GROWTH MANAGEMENT DEPARTMENT STAFF REPORT
PALM VALLEY OVERLAY DISTRICT
March 27, 2024 Public Meeting
ARC 2023-15 Boathouse Restaurant- Front Canopy

To: Architectural Review Committee
Staff: Brandon Tirado, Planner
Date: March 15, 2024

Summary of Request: Applicant is Requesting design approval to install a new canopy, fencing, landscaping, pavers, columns, and lighting for an outdoor dining area, located at 240 A1A North, within the Merchants Plaza Shopping Center. The applicant has confirmed they will be providing physical color/material samples for the Board to review at the hearing.

Figure 5: Outdoor Seating Fence

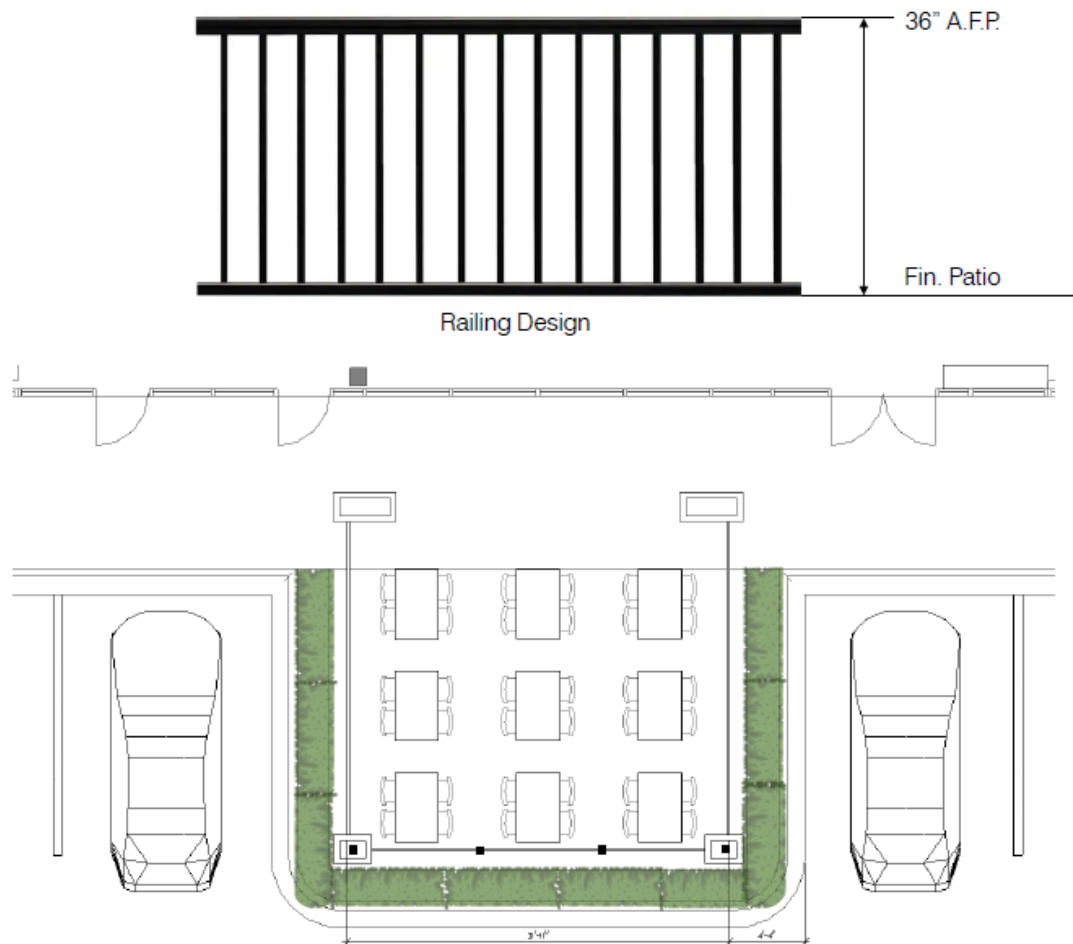
Figure 5. demonstrates the appearance and locations of fencing around the outdoor seating area. The fence does not appear to be in conflict with PVZDR Section Q.5.a.

Figure 6: Column Profile

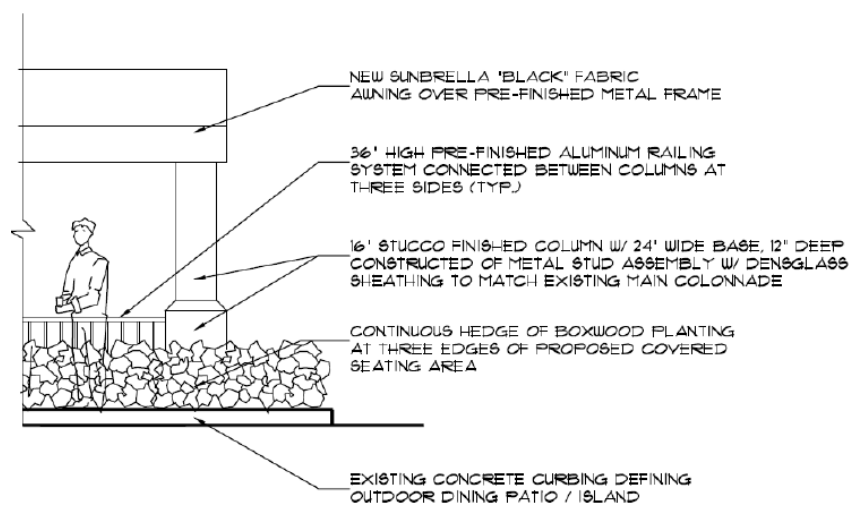
Figure 6. illustrates the typical column profile proposed in this request. As seen in Figure 2 & 3, it appears that there will be 4 columns that will have a stucco finish and the two center columns will retain their 3" x 3" x 1/4" tube column.
